KAMOMARSH

Appendix B: Planting Palette

RFI – 12 November 2021

Addendum RFI Report

BOBS COVE - WAIMARINO
PROPOSED PLANTING ZONES

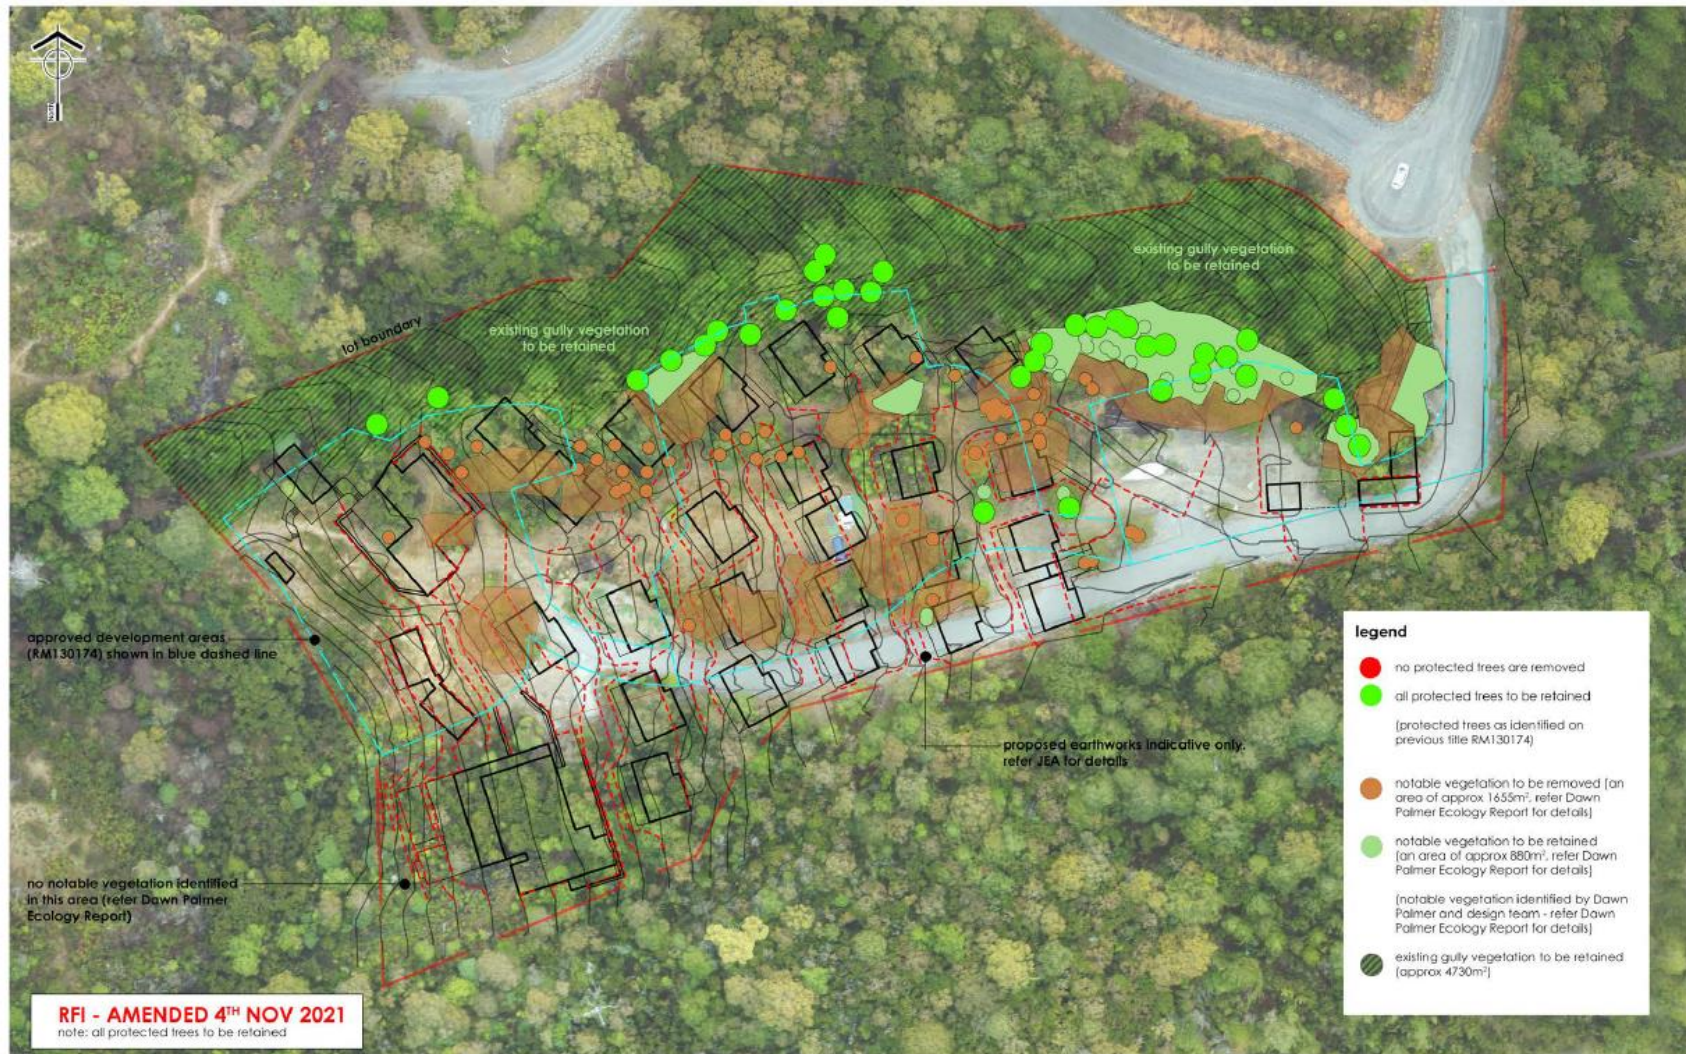
16. Under the Waimarino proposal, the full range of species diversity present on site and along the property boundary would be protected within the vegetation to be retained as part of the development proposal – refer KamoMarsh Landscape Architect plans SK55 (Attachment F) - RFI Amended – 4 November 2021. This includes:

77. KMLAP Plan SK55 (Attachment F) identifies the area to be planted around and between the proposed units with a total of 6730m² of new planting from Appendix B: the Planting Palette prepared by KMLA.
